Staff Report

Infill Housing Design Review Committee

File Number: 3-B-22-IH

Location: 3312 McPherson St. **Parcel ID** 81 P A 025
Zoning: RN-2 (Single-Family Residential Neighborhood)
District: Lonsdale Infill Housing Overlay District

SHEET NO.
SP1

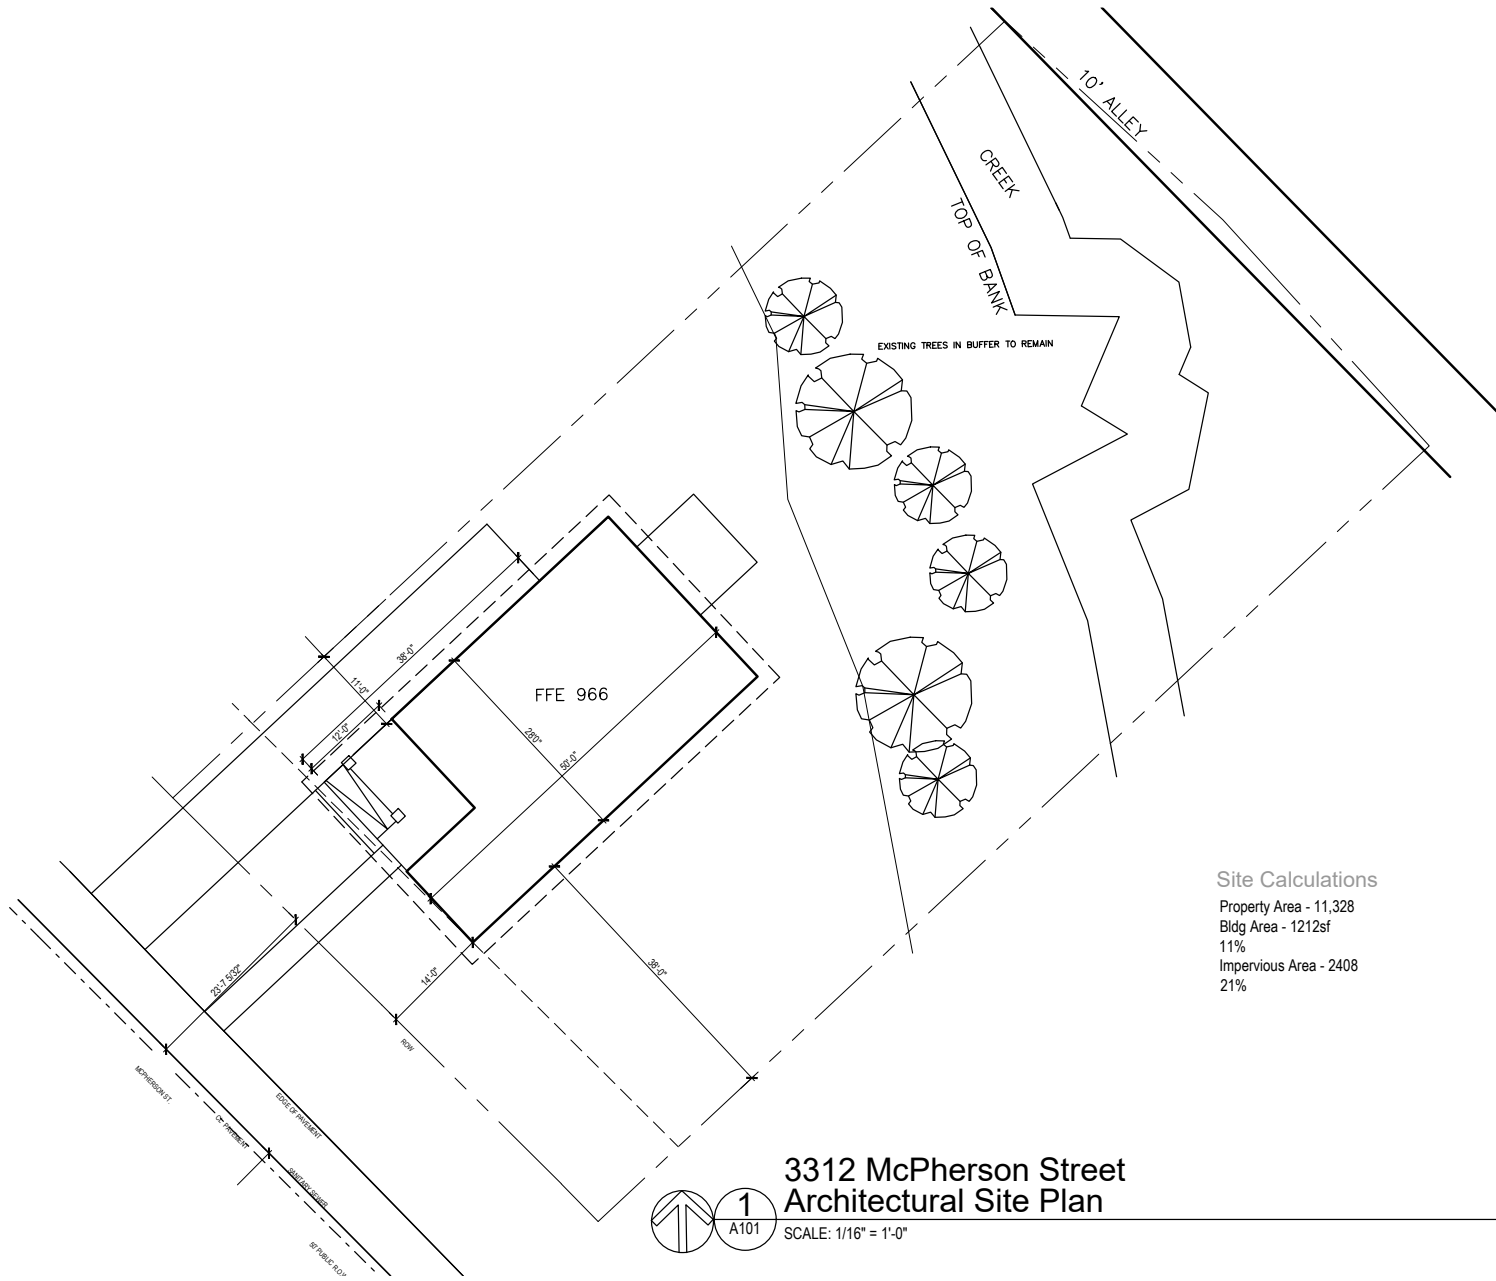
1. The average front setback of the blockface is 17'. The applicant has proposed a front setback of 14' to respect a 30' blue line stream buffer and existing trees to the rear of the property line. The proposed front setback for 3312 McPherson Street will be reflected in the adjacent new construction at 3314 and 3318 McPherson Street and create a consistent front yard space along the block. The house is not centered on the lot, with a proposed right side setback of 38'; however, the side setback will also accommodate the existing tree buffer around the creek. The site plan includes a walkway from the front door to the street.

2. The proposal for 3312 McPherson Street incorporates a proposed subdivision of land (reflected on engineer's survey drawings. Platting the three properties of 3312, 3314, and 3318 McPherson Street into three even lots of 77.38', 60', and 60' wide (respectively) will create more consistently-sized lots with evenly-spaced houses.

4. The parking is proposed to extend off McPherson Street, with an 11' wide by 38' long concrete driveway. There is no alley on the east side of McPherson Street, and the rear of the property features a blue line stream with a 30' buffer. Alley-accessed parking would not be possible on this property. The proposed driveway meets Infill Housing guidelines for new construction without an alley, placing cars at least 20' behind the front façade of the house with a driveway off the street limited to one lane.

Due to the stream in the rear of the property, there are a number of stormwater requirements associated with the house's finished floor elevation, driveway design, and buffer zone. These items can be addressed in permitting. The final site plan submitted should meet City Engineering's requirements and all modifications to the parking should remain within the Infill Housing design guidelines.

- 1) Final site plan to reflect City Engineering and Stormwater comments; any modifications to driveway or parking to meet Infill Housing design guidelines;
- 2) Any substantial deviation on final plats from the proposed subdivision of land to require further review by the DRB;
- 3) Final elevation drawings and foundation design to reflect Engineering's requirements for finished floor elevation, along with the required zero step entry, with modifications to be approved by staff.

3312 McPherson Street
Elevations
1
A201 SCALE: 1/8" = 1'-0"

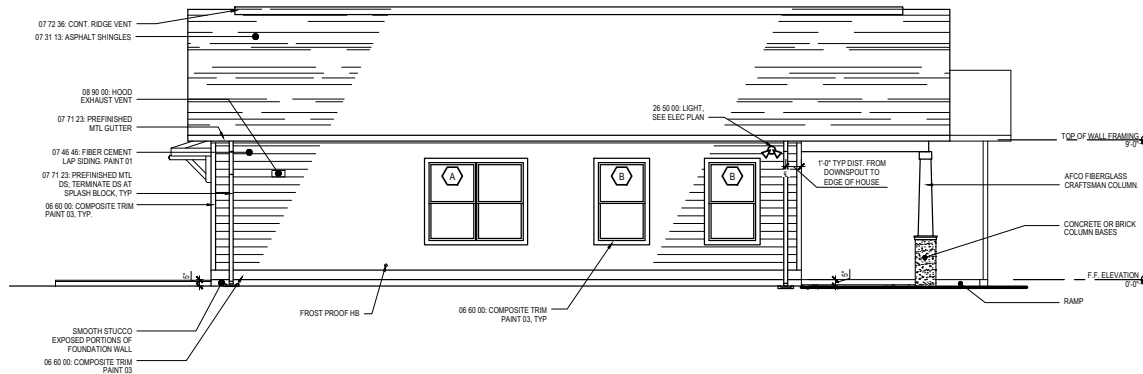
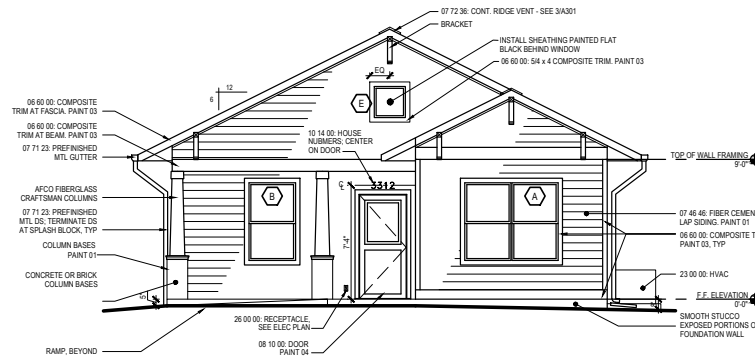
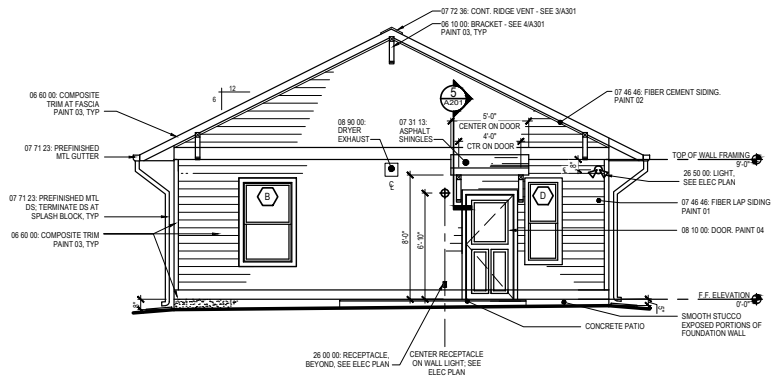
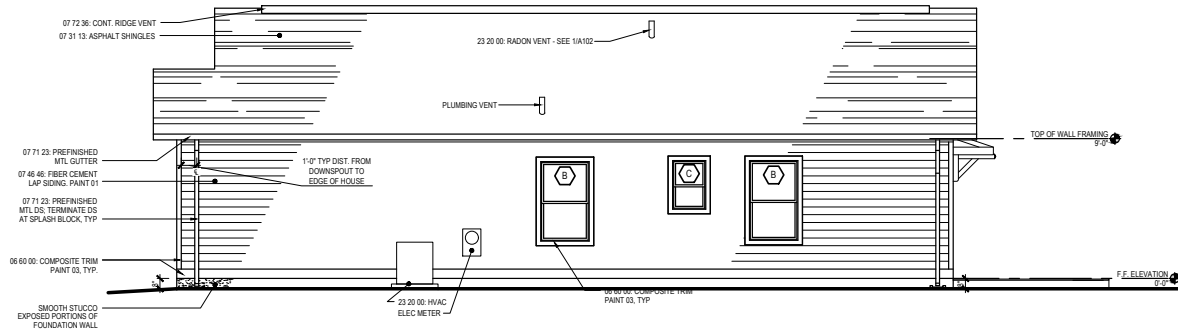
5. The house's three-bay façade is comparable in scale to other houses along the street, with a similar façade width (excluding the Ranch house). The design features sufficient complexity, with a projecting front gable roof massing on the façade. The house features a concrete slab foundation, which is lower in height than typical historic foundations. However, the concrete slab foundation accommodates an accessibility ramp from the parking to the front porch, meeting a requirement of the City Homemakers Program to provide a zero-step entry. Existing houses on the block have similarly low foundations. City Engineering requires the foundation to be modified to provide a finished floor elevation of 2' above the adjacent road grade; which may require modifications to the elevation drawings and proposed zero step entry.

8. The roof pitch is sufficiently steep for the neighborhood context, and the projecting bay on the façade adds complexity to the overall design. The additional details of roof brackets and wide eave overhangs contribute to the design.
